RE: ROSE PLAZA/GENERAL DEVELOPMENT PLAN REVIEW #1

TO: Josh Potter, Assistant Director of Community Development
FROM: Jonathon Zabrocki, P.E., Consulting Village Engineer
DATE: October 2, 2017
RE: Rose Plaza (PZC 17-026)
Weber Road and Renwick Road
Concept Plan Review

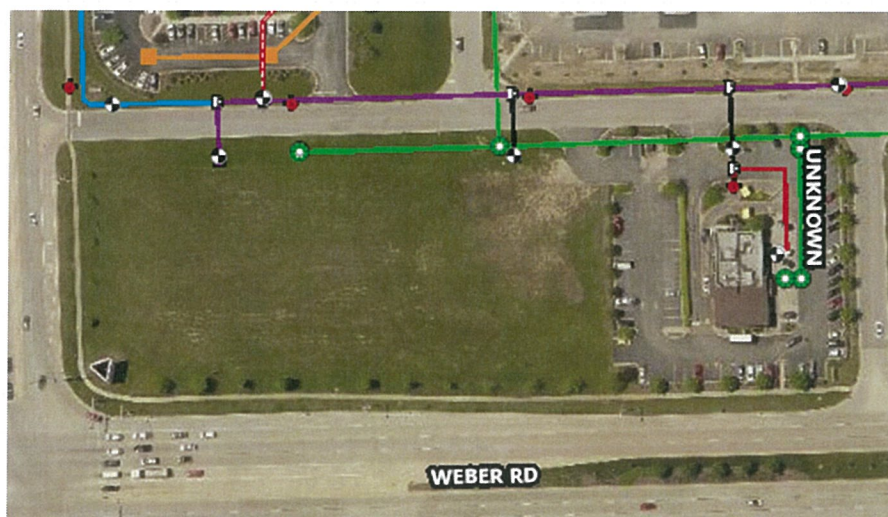
- 2.1. All existing water, sanitary, and storm utility features (with sizes labeled) must be shown on the engineering drawings. Here is a snapshot from the Village's GIS system:
